Technical Service Bulletin

Subject: AUTO A/C BLOWS WARM AIR	Bulletin No.: 07-003/17
	Last Issued: 03/24/2017

This bulletin supersedes the previously issued bulletin(s) listed below: The changes are noted in Red.

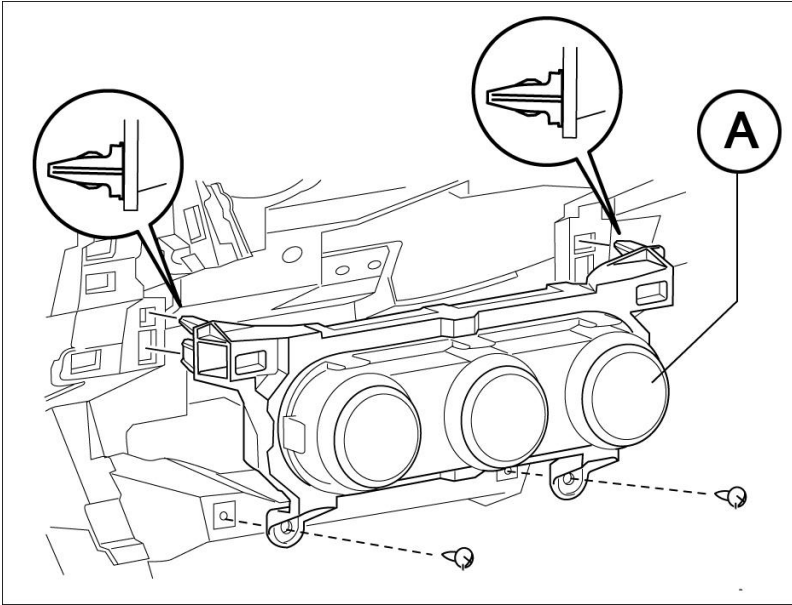
The climate control unit logic has been changed to correct this concern.

2. Replace the climate control unit (A). Refer to **MGSS**online:

- CX-3 - CLIMATE CONTROL UNIT REMOVAL/INSTALLATION [FULL-AUTO AIR CONDITIONER].
- Mazda2- CLIMATE CONTROL UNIT REMOVAL/INSTALLATION [FULL-AUTO AIR CONDITIONER].
